Number: SB 2X-32-19 R3

Revised: June 28, 2012

SNS SUBJECT: 32-20 NOSE GEAR - Nose Landing Gear Assembly Inspection and Reinforcement

Figure 1
Nose Landing Gear Assembly Inspection

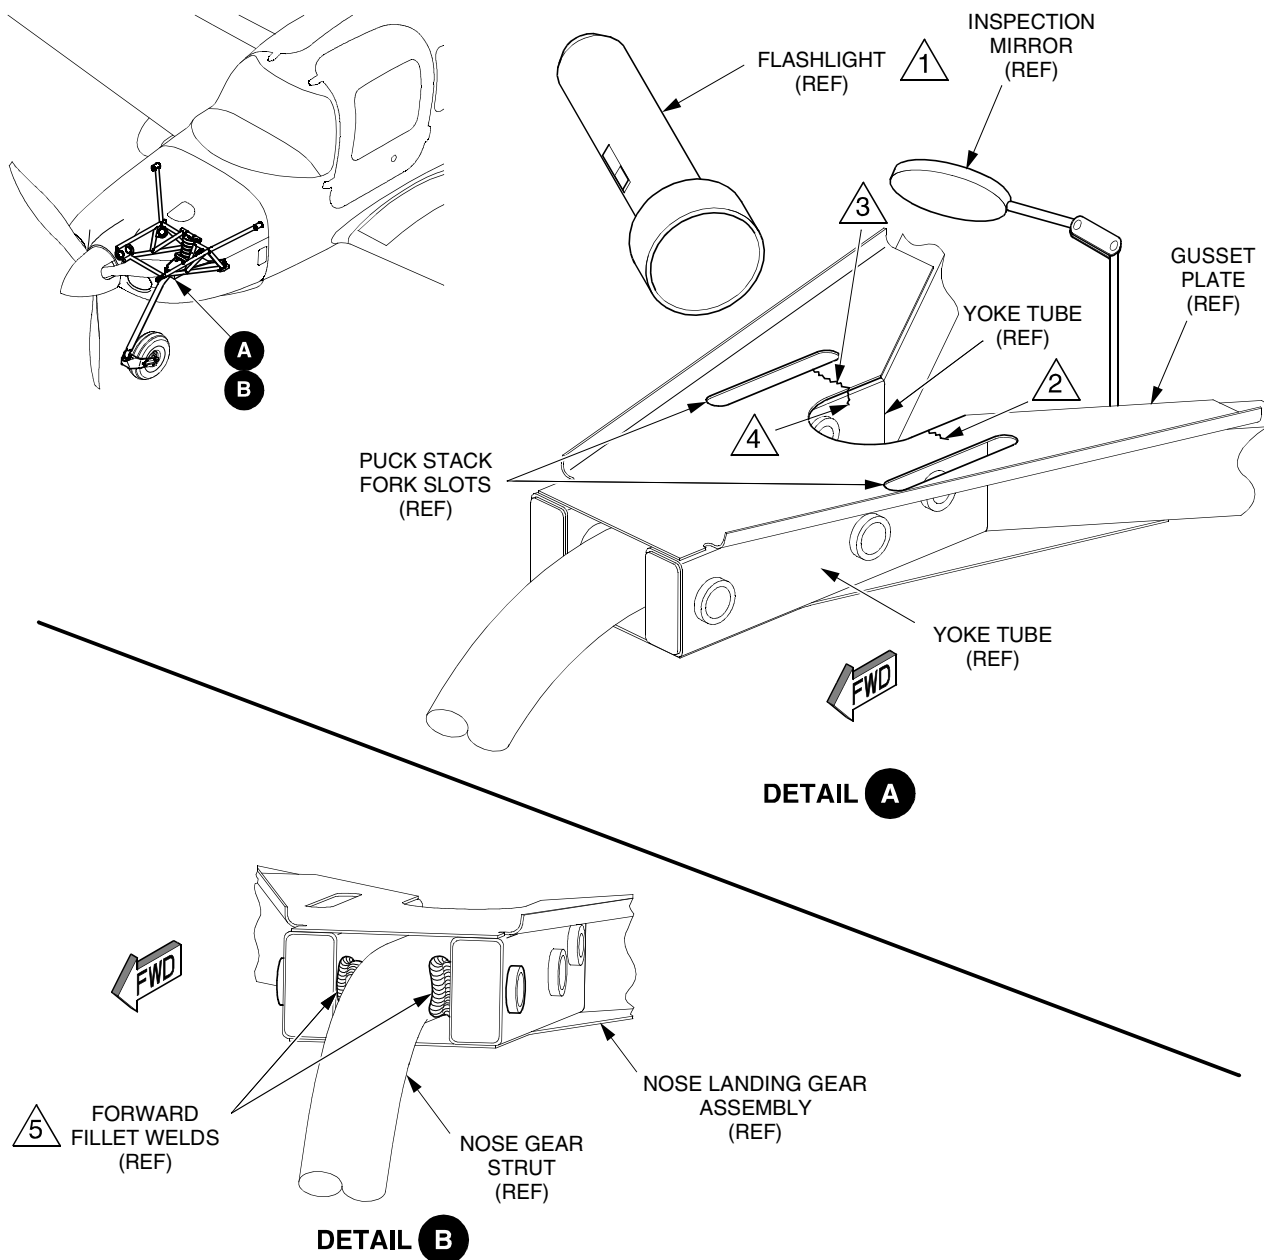
D. Perform Upper Gusset Plate Inspection. **(See Figure 1)**

At upper gusset plate, use flashlight and inspection mirror to visually inspect in accordance with FAA AC 43.13-1B, Chapter 5, Section 2 for evidence of cracking developing through the gusset plate and extending toward the puck stack fork slots.

- If no cracking is found, re-inspect Upper Gusset Plate every 100 flight hours in accordance with Chapter 5-20, Scheduled Maintenance Checks. (Refer to AMM 05-20)
- If cracking is found but does not extend into yoke tube, and does not reach either puck stack fork slot, crack length is allowable for continued operation. Re-inspect Upper Gusset Plate every 100 flight hours in accordance with Chapter 5-20, Scheduled Maintenance Checks. (Refer to AMM 05-20)
- If crack reaches either puck stack fork slot, NLG assembly must be replaced within 100 flight hours. (Refer to AMM 32-20)
- If crack extends into yoke tube, contact Cirrus Design for disposition.

E. Perform Forward Nose Gear Strut Fillet Weld Inspection. **(See Figure 1)**

(1) At upper section of nose gear strut where strut enters the NLG assembly, use flashlight and 10X magnifier to visually inspect forward surface of forward fillet welds attaching strut to NLG assembly in accordance with FAA AC 43.13-1B, Chapter 5, Section 2 for indications of damage. If welds show indications of damage (i.e. cracks, rust lines, loose paint), determine extent of damage.

- 1 At upper gusset plate, use flashlight and inspection mirror to visually inspect upper gusset plate for evidence of cracking developing through the gusset plate and extending toward the puck stack fork slots in accordance with FAA AC 43.13-1B, Chapter 5, Section 2.

- 2 If crack does not extend into yoke tube, and does not reach either puck stack fork slot, crack length is allowable for continued operation. Re-inspect Upper Gusset Plate every 100 flight hours in accordance with Chapter 5-20, Scheduled Maintenance Checks.

- 3 If crack reaches either puck stack fork slot, NLG assembly must be replaced within 100 flight hours.
- 4 If crack extends into yoke tube, contact Cirrus Design for disposition.

- 5 At upper section of nose gear strut where strut enters the NLG assembly, use flashlight and 10X magnifier to visually inspect the forward surface of the forward fillet welds attaching the strut to the NLG assembly in accordance with FAA AC 43.13-1B, Chapter 5, Section 2.

Figure 2
Nose Landing Gear Assembly Reinforcement

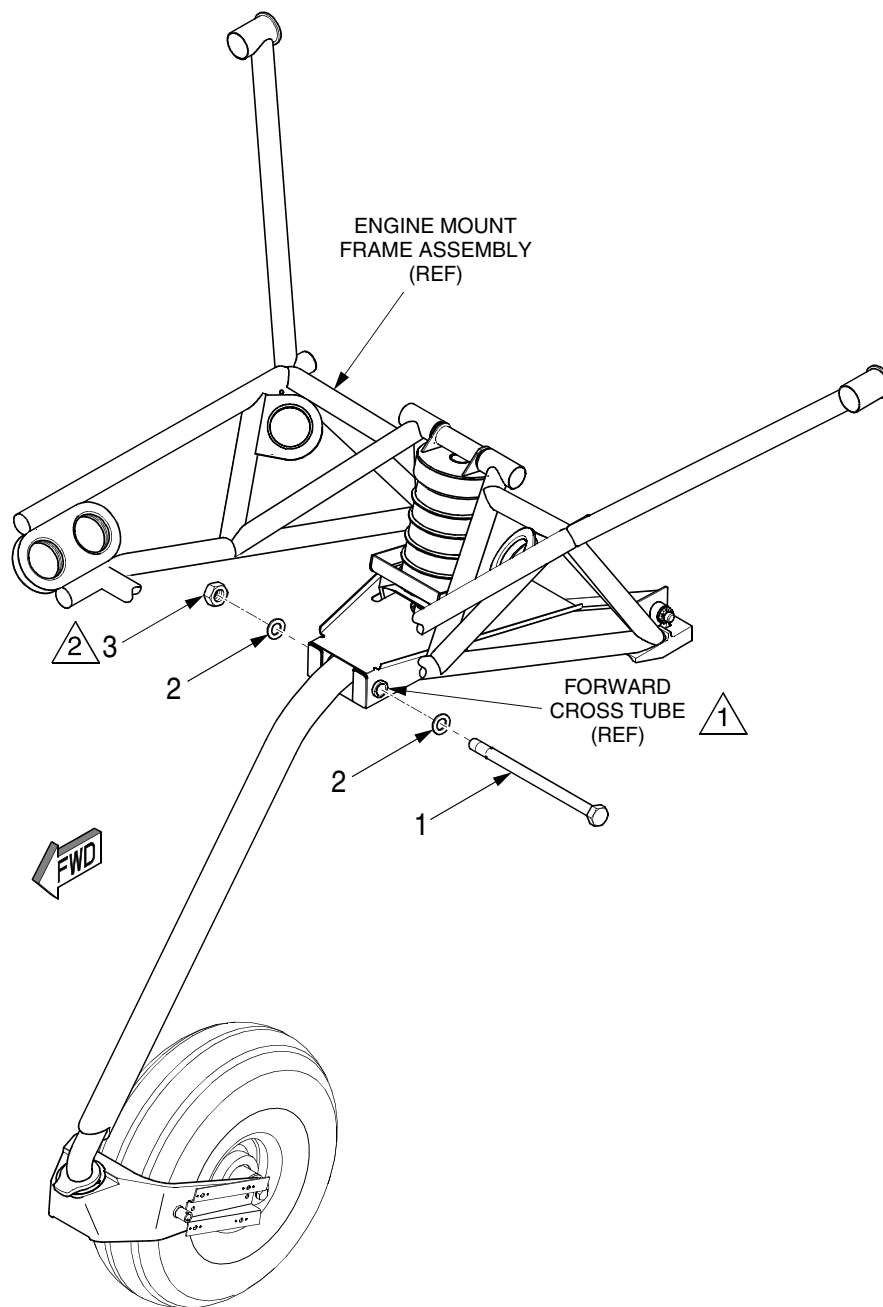
F. Approved Repair - Nose Landing Gear Reinforcement **(See Figure 2)**

- (2) Apply sufficient grease to fully coat bolt.
 - (3) Ensure bolt passes through forward cross tube of NLG assembly. If necessary, lightly tap bolt through forward cross tube with hammer.

- (4) If inner diameter of cross tube prevents bolt insertion, use reamer to enlarge cross tube to 0.635 inch (16.129 mm) maximum.
 - (5) Using compressed air, remove any debris from forward cross tube.

- (6) Install bolt, washers, and nut through forward cross tube of NLG assembly. Torque to 1100 to 1300 in-lb (124.3 to 146.9 Nm).
- G. Apply paint and primer to inspection areas as necessary. (Refer to AMM 51-20)

- ① If inner diameter of cross tube prevents bolt insertion, use reamer to enlarge cross tube to 0.635 inch (16.129 mm) maximum.
- ② Torque to 1100 to 1300 in-lb (124.3 to 146.9 Nm).
